Intel[®] I / O Controller Hub 6 (ICH6) Family

Specification Update

May 2012

Order Number: 301474-030

Figure 1. LPC Bridge SERR# Generation

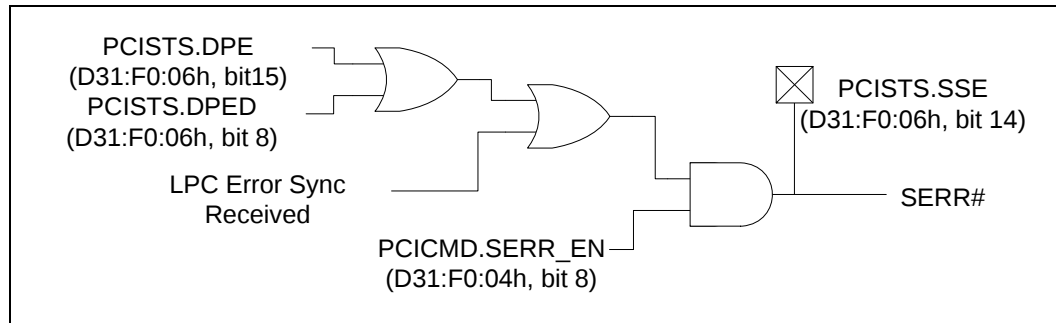
The first class of errors is parity errors related to the backbone. The LPC Bridge captures generic data parity errors (errors it finds on the backbone) as well as errors returned on the backbone cycles where the bridge was the master and parity error response is enabled. If either of these two conditions is met, and with SERR# enable (PCICMD.SERR_EN) set, SERR# will be captured.

Additionally, if the LPC Bridge receives an error SYNC on LPC bus, an SERR# will also be generated.

The following is added as section 5.5.2:
